### CITY OF SHELBYVILLE

### PLAN COMMISSION

### Site Development Plan: PC 2023-5; Shelby Storage; SDP

# SHELBY STORAGE 1706 McCall Dr. SHELBYVILLE, IN 46176 ZONED: IL

C101

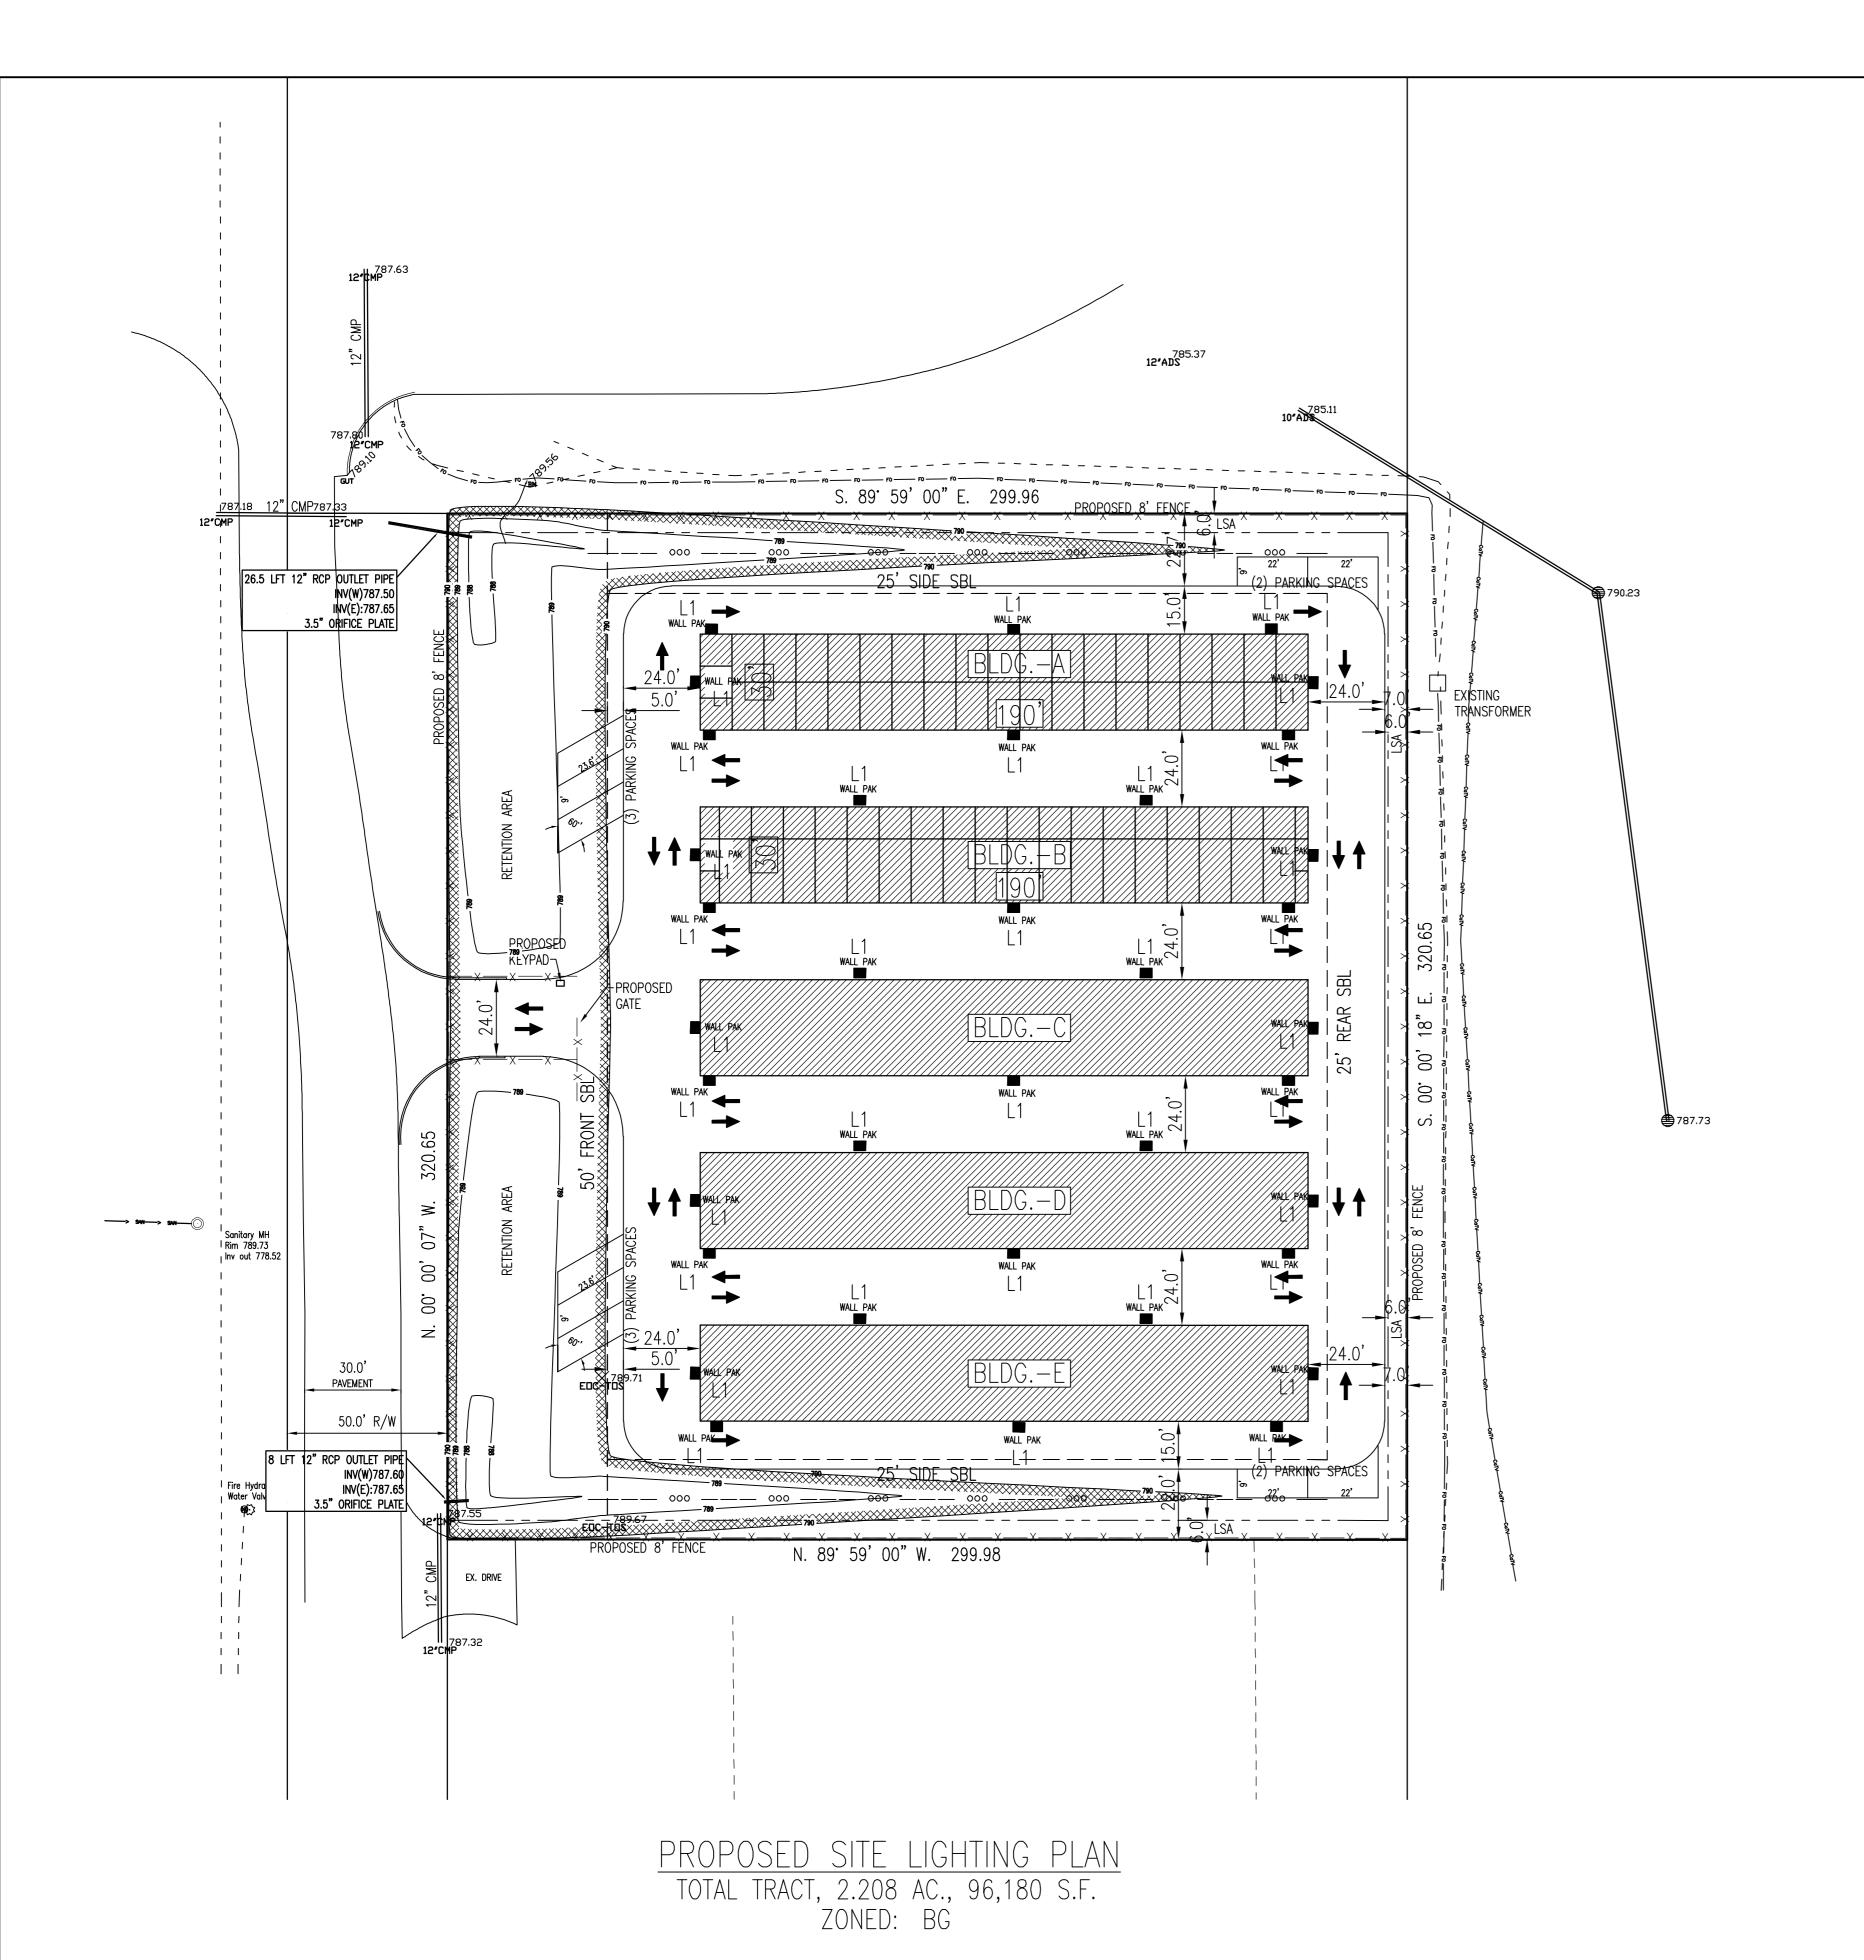
Page C101 calls for the area for Buildings D and E to remain as grass for RV and Trailer parking until such time as the buildings would be constructed. Per the UDO RV and Trailer parking must be on a paved surface. Petitioner needs to eliminate RV and Trailer parking.

- 1. City Engineer's Office must approve a final drainage plan and report that complies with all City Standards prior to the issuance of any permits.
- 2. The landscape plan is revised and approved by the City Planning Department.
- 3. The storage of Recreational Vehicles (RV) and trailers are not permitted unless meeting all the requirements of UDO Outdoor Storage Standards.

PROPOSED LANDSCAPING PLAN DATE: NOV. 14, 2022 PROJECT NO.: 202209 SHEET NO. C106

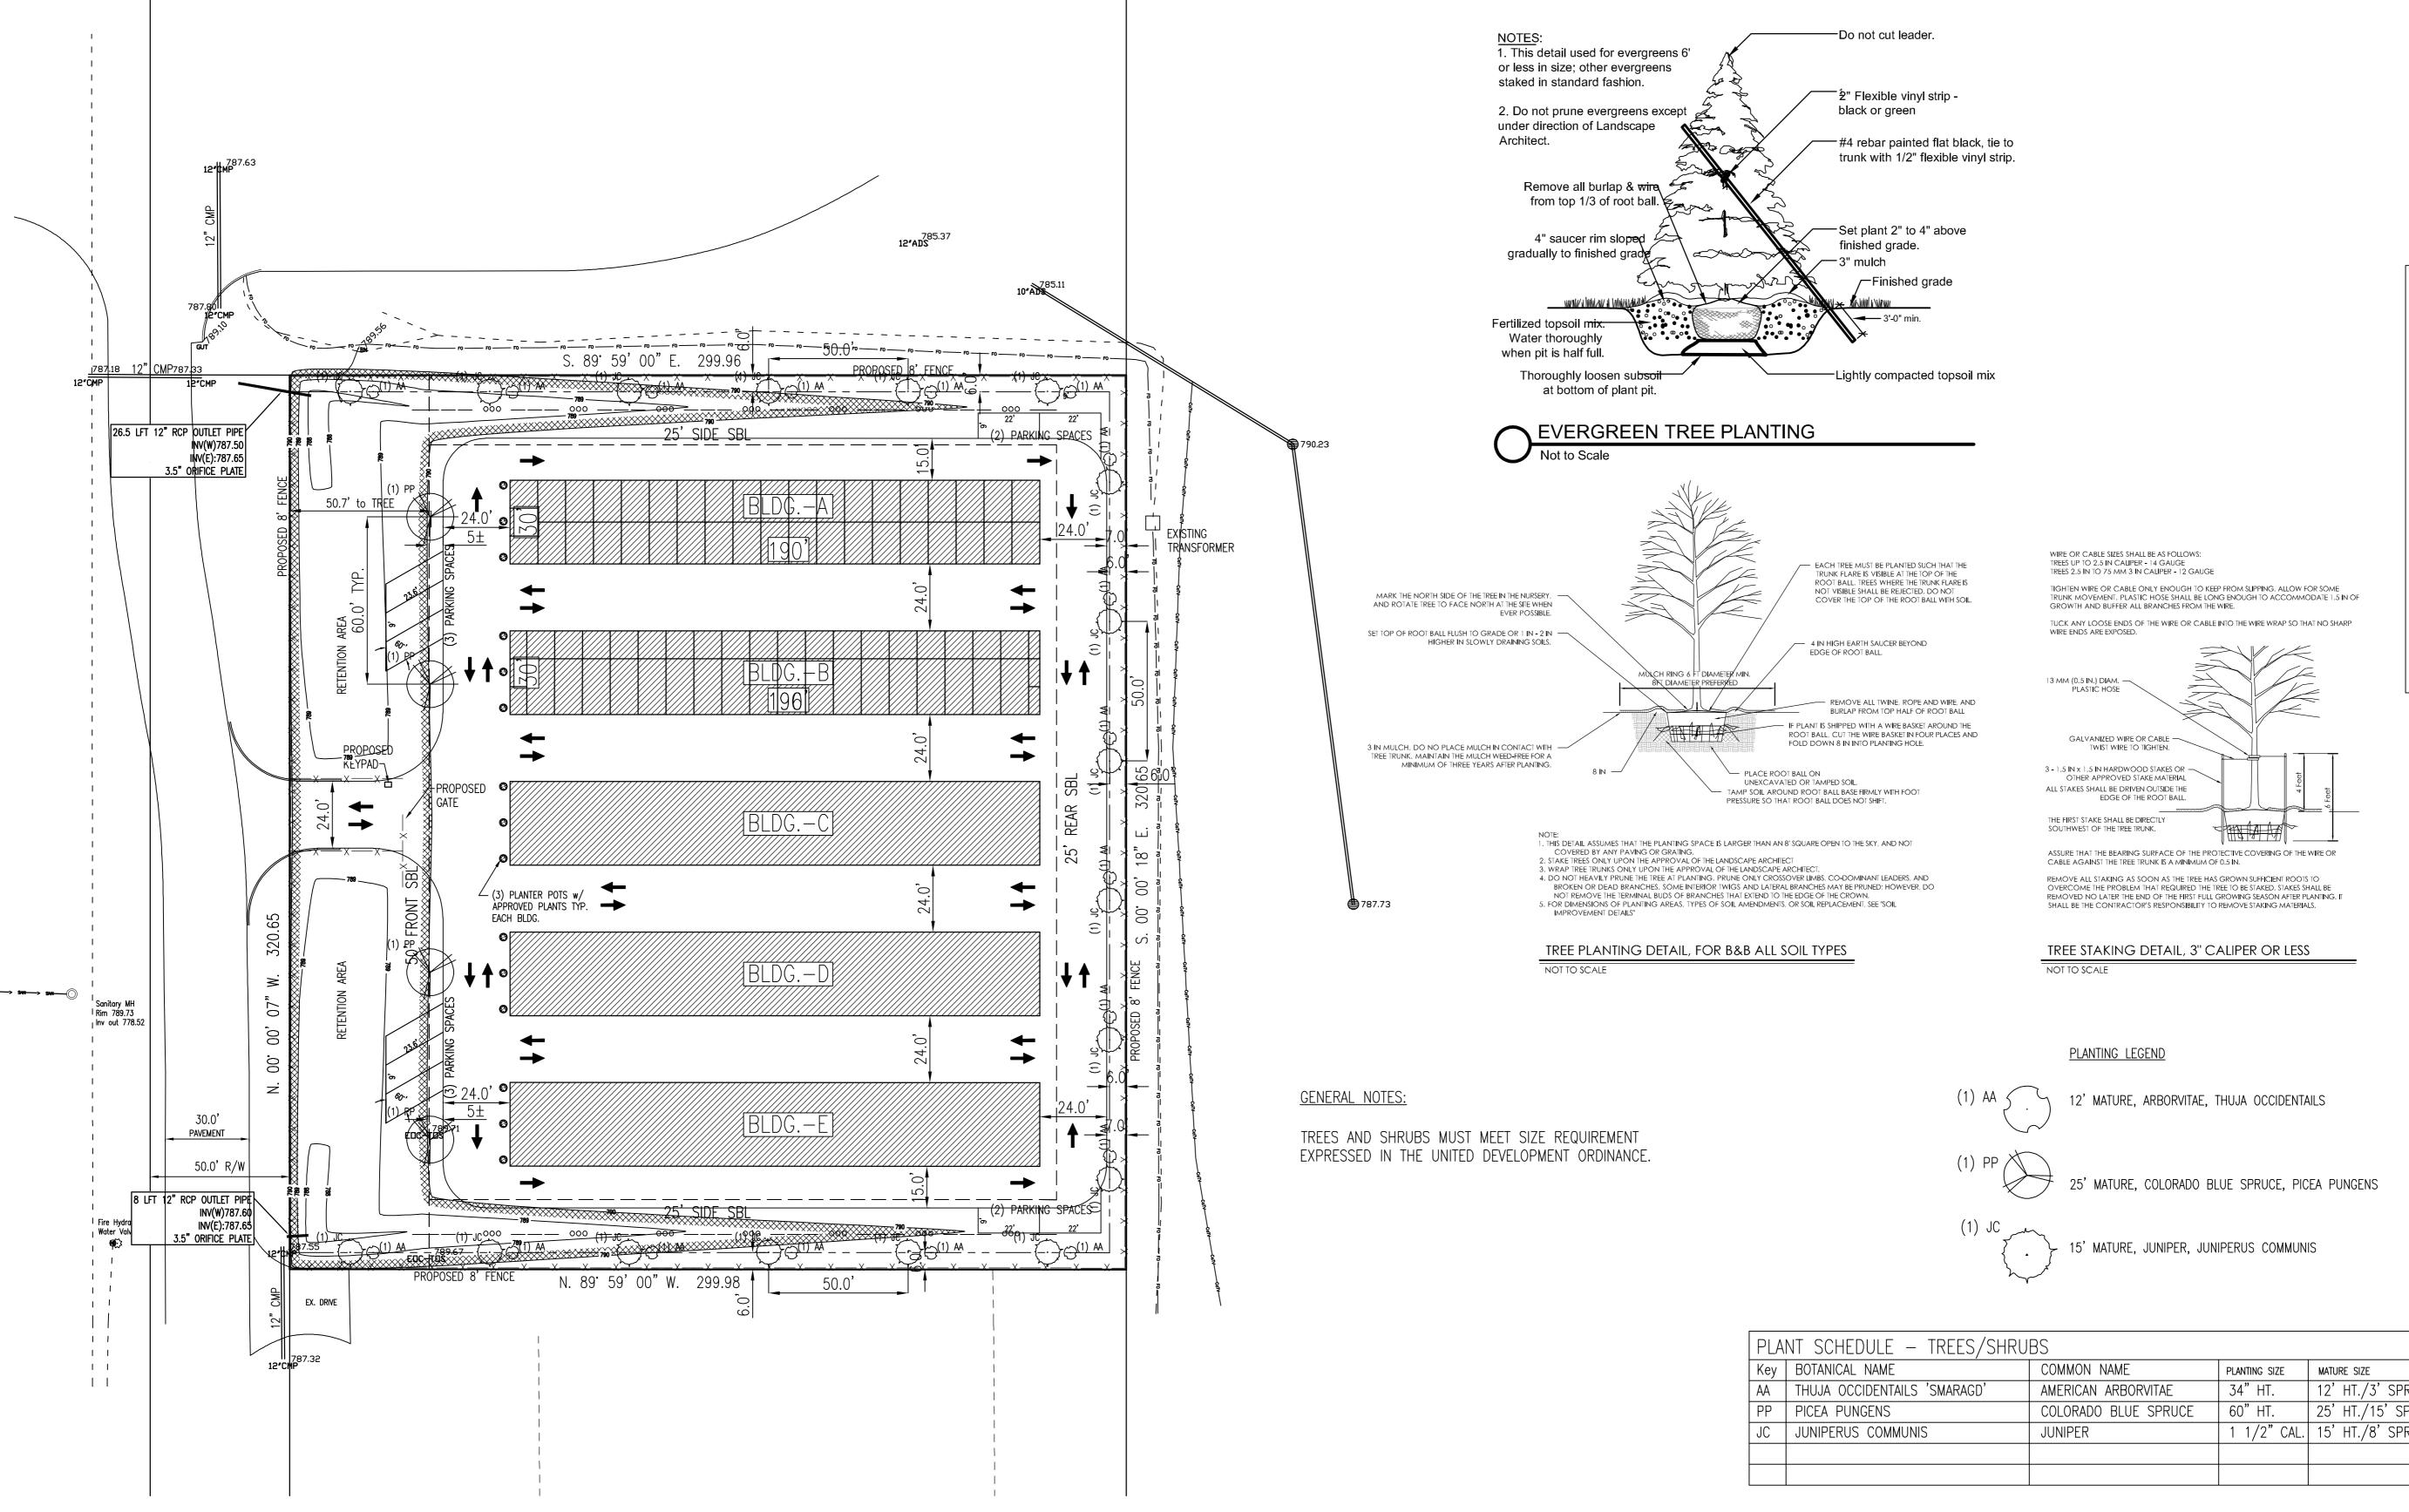
The petitioner is not meeting this standard. Please provide a revised landscape plan.
